1990 Corvette: Service Bulletin: SIR Diagnostics and Procedures to Prevent Codes 16 and 26 Due to Corrosion Revised

Subject: SERVICE MAN. UPDATE SEC.9J A/B REV. SIR DIAGNOSTIC PROCEDURE

Model and Year: 1990 CORVETTE

Bulletin Number: 90-436-9J - (11/07/1991)

FORWARD DISCRIMINATING SENSORS Figures 1 & 2 -----

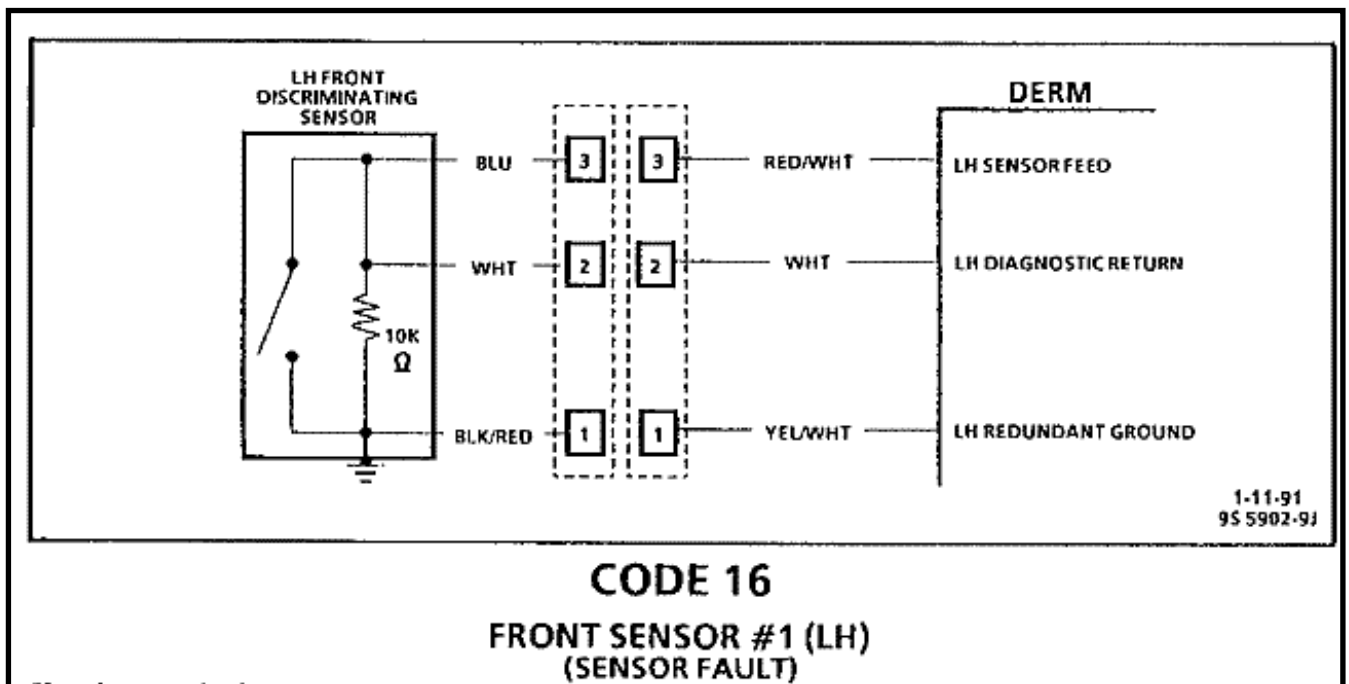
Caution should be used to assure proper location of sensors to the front frame rails. The keying of the sensors to the frame rails through the differently sized mounting bolt holes in the sensor mounting plate should never be modified in the field.

- Proper operation of the forward discriminating sensor requires the sensor be rigidly attached to the vehicle structure and that the arrow on the sensor be pointing toward the front of the vehicle.

1. Apply a thin layer of special grease P/N 12345579 to the frame rail mounting surface and the mounting flange of the sensor. Do not apply the grease to the mounting bolts or holes.
2. Forward discriminating sensor, with arrow pointing toward front of vehicle.
3. External tooth lock washers, P/N 11501869 (8 mm) and 121753 (6 mm) to mounting bolts.
4. Sensor mounting bolts. Ensure that washers are between bolt head and sensor mounting flange, not between mounting flange and frame rail.

- Front (13 mm head) bolt to 25 N.m (19 lb. ft.) - Rear (10 mm head) bolt to 14 N.m (125 lb. ft.)
5. Sensor electrical connection, then clip completed connection into retainer.
 6. Position windshield washer reservoir; install retaining bolts.

SENSOR
PIGTAIL
CONNECTOR
(Front View)

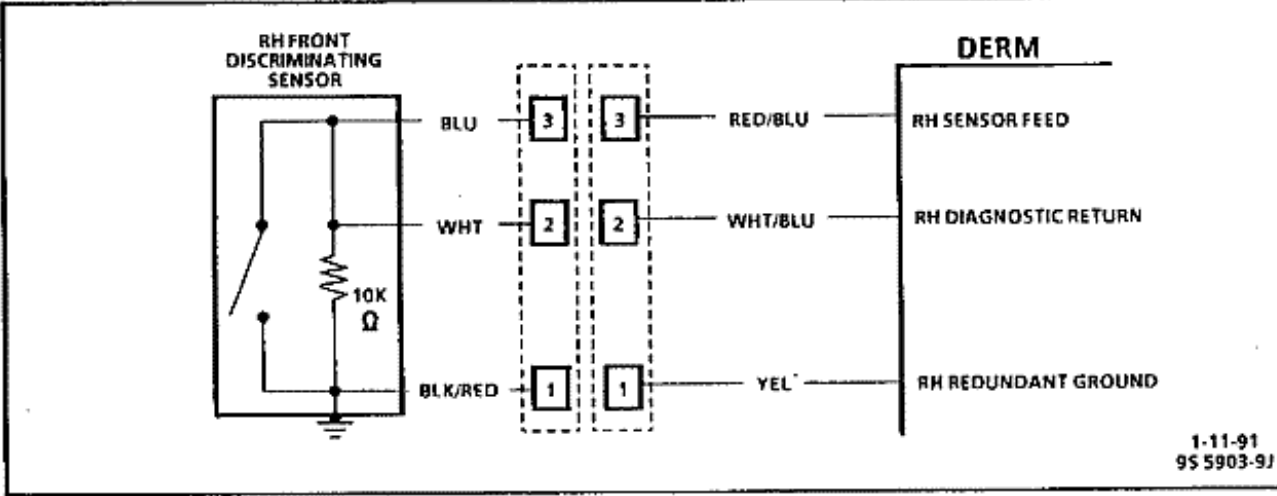
- 1
- IGNITION "OFF."
 - DISCONNECT SENSOR CONNECTOR.
 - USING ADAPTERS FROM J 37808-10 AND DVM J 34029-A OR DVM J 39200, MEASURE THE RESISTANCE BETWEEN TERMINALS IN THE SENSOR PIGTAIL CONNECTOR AS SHOWN BELOW. NOTE MEASUREMENTS FOR EACH CHECK.

SENSOR TERMINALS	RESISTANCE
1 AND 2	ABOUT 10,000 Ω
1 AND 3	ABOUT 10,000 Ω
2 AND 3	LESS THAN 1 Ω

- 3
- REMOVE SENSOR; REFER TO "LEFT SENSOR" ON ATTACHED PAGES.
 - CLEAN ANY PAINT AND/OR CORROSION FROM SENSOR AND FRAME RAIL MOUNTING POINTS AND MOUNTING BOLTS.
 - INSTALL SENSOR; REFER TO "LEFT SENSOR" ON ATTACHED PAGES TO APPLY SPECIAL GREASE AND LOCK WASHERS UPON INSTALLATION TO HELP PREVENT RECURRENCE OF CODE 16 DUE TO CORROSION.
 - CLEAR CODES (TECH 1 PREFERRED).
 - IGNITION "OFF," THEN "ON."
 - DOES CODE 16 RESET?

- 4
- REMOVE SENSOR; REFER TO "LEFT SENSOR" ON ATTACHED PAGES.
 - CLEAN ANY PAINT AND/OR CORROSION FROM FRAME RAIL MOUNTING POINTS AND MOUNTING BOLTS.
 - INSTALL NEW SENSOR; REFER TO "LEFT SENSOR" ON ATTACHED PAGES TO APPLY SPECIAL GREASE AND LOCK WASHERS ON INSTALLATION TO HELP PREVENT RECURRENCE OF CODE 16 DUE TO CORROSION.
 - CLEAR CODES (TECH 1 PREFERRED).
 - IGNITION "OFF," THEN "ON."
 - DOES CODE 16 RESET?
